From: Logan, Dennis
Sent: Wednesday, May 09, 2012 3:34 PM
To: 'Richard Domingue'
Cc: Cooper, Paula
Subject: RE: NRC response to NMFS additional information request
Attachments: 2012-05-08 Additional Info request responses for NMFS .docx

RE: Additional Information Request regarding license renewal of The Columbia Generating Station
Consultation No. F/NWR/2011/05286.

Juvenile Fish Screen Design Summary

Figure 1. Intake system plan and profile
(WPPSS 1980)

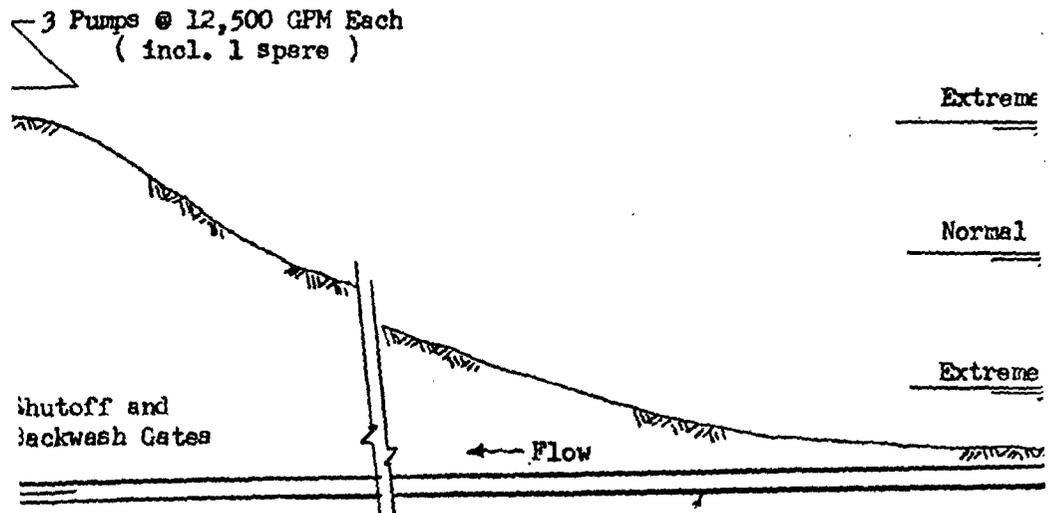
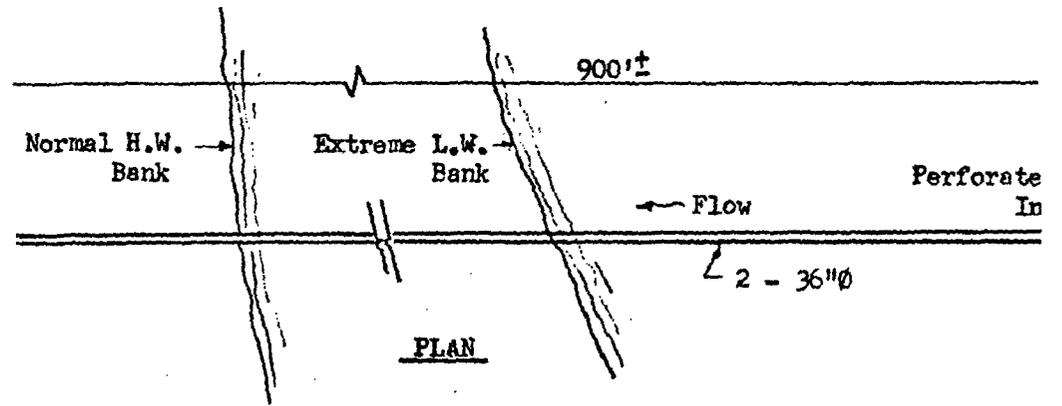
II. Water Surface Elevation (WSE) Data. Generally indicate method used to determine and estimate flows and elevations. Elevations can be relative to local benchmark, and period of record should be limited to the downstream juvenile migration season.

Elevation of the intakes in relation to the river is shown in Figure 1.

Figure 2. Perforated intake plan and section
(WPPSS 1980)

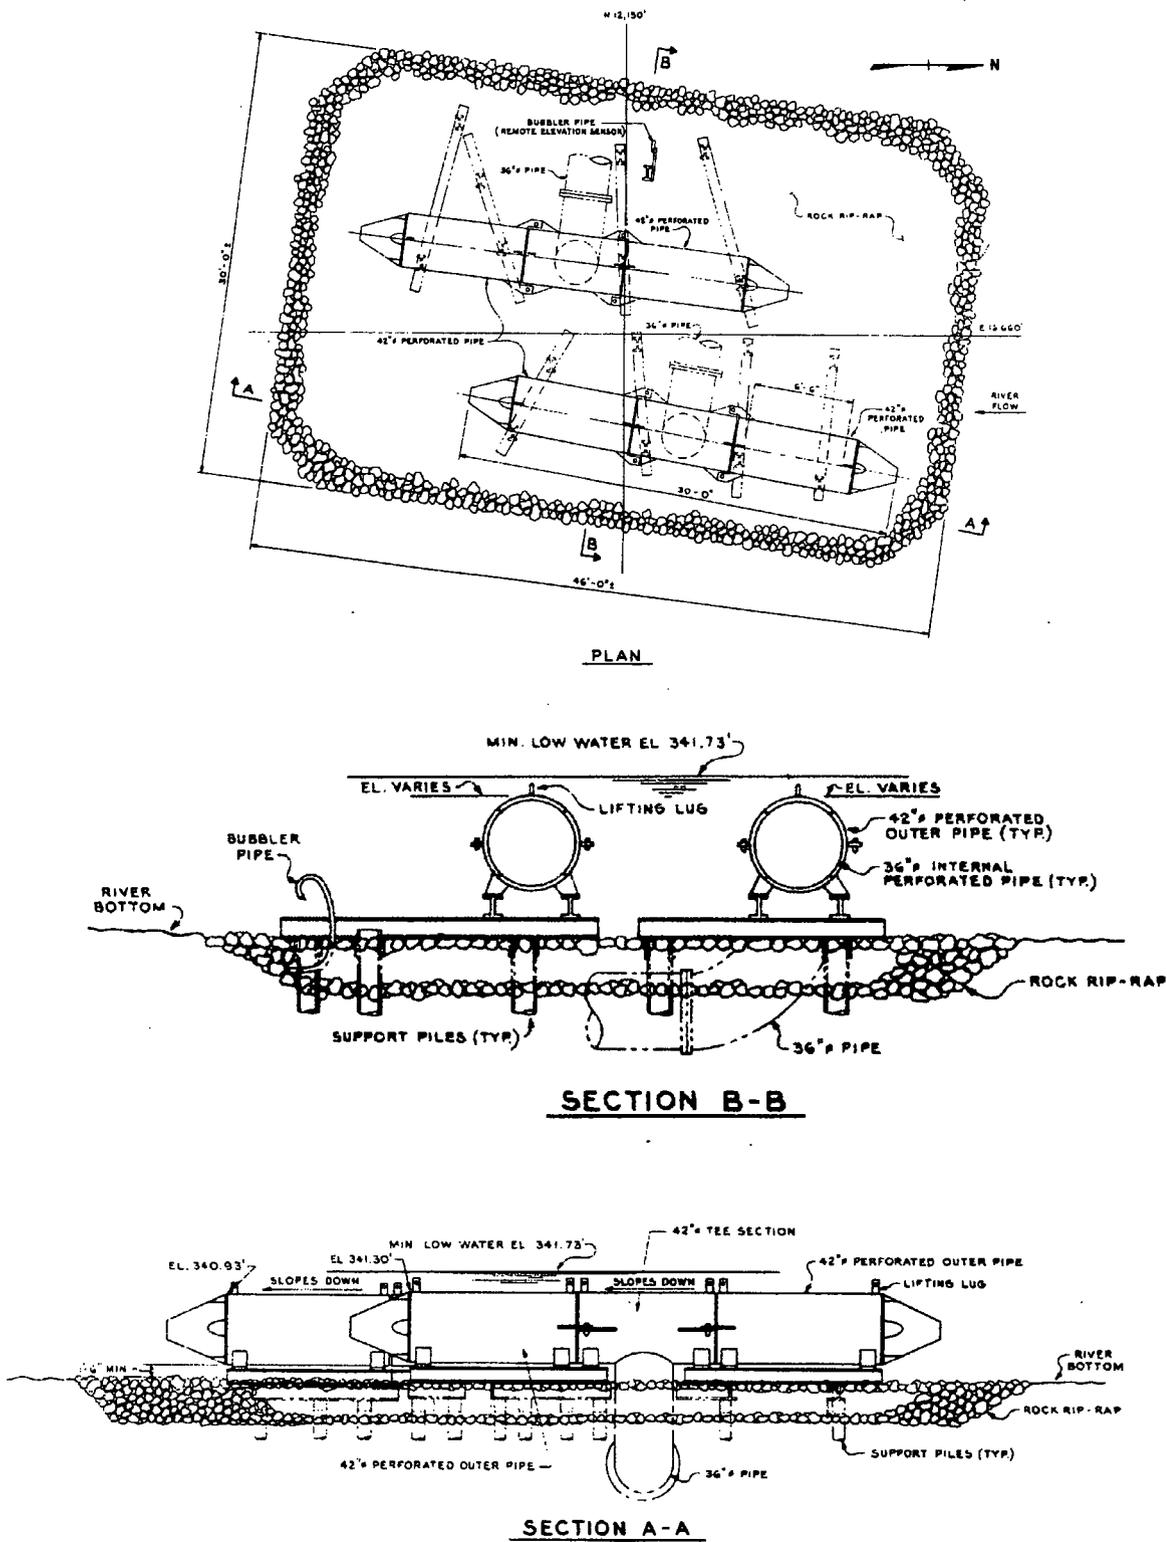
1. Type of screen (rotary drum, fixed vertical, etc.): Attach detailed drawing of screen, including dimensions, mesh, seals

Each intake structure is composed of two intake screens that are each 6.5 ft (2 m) in length and mounted end to end. The remaining length of the intake structure consists of two solid cones at either end of the structure. The intake screens consist of an outer and inner perforated pipe sleeve (WPPSS 1986). The outer sleeve has a 42 in. (107 cm) diameter sleeve with 3/8 in. (9.5 millimeter (mm)) diameter holes (composing 40 percent of the surface area). The inner sleeve has a 36 in. (91 cm) diameter sleeve with 3/4 in. (19 mm) diameter holes (composing 7 percent of the surface area). The intake screens are designed to distribute the water flow evenly along its surface. The intake structure is mounted above the riverbed and approximately parallel to the river flow, about 300 ft (91 m) from the shoreline at Columbia River Mile (RM) 352. The location of the intake screens is in the deepest part of the channel, and the river bottom varies around the intake structure from exposed Ringold conglomerate to boulders, cobble, gravel, and sand (WPPSS 1980, 1987).

Figure 2 shows a schematic of the intake (plan and section views). Figure 3 shows a spare perforated pipe for the intake structure.

Figure 4. Location of pumphouse, pipelines, intakes, and outfalls

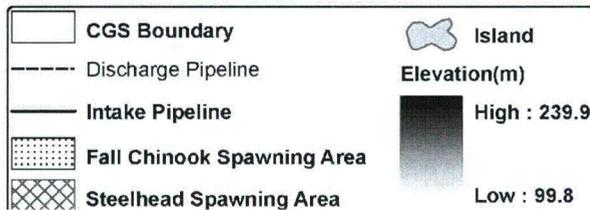
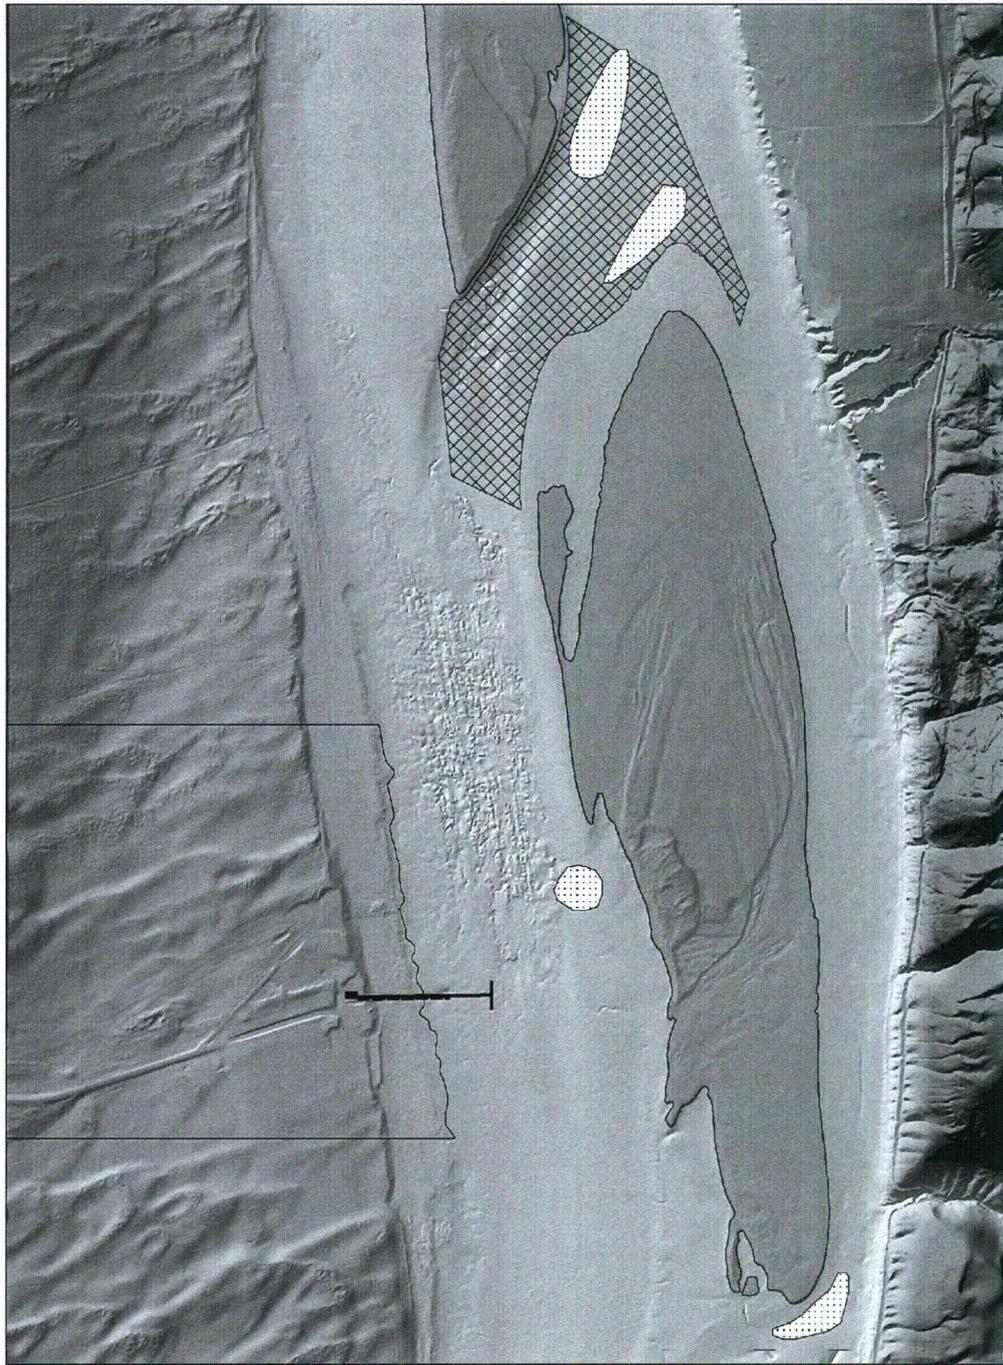
VI. Site sketch. Include screen location, river geometry near screen site.

Response: See Figures 2 and 4.
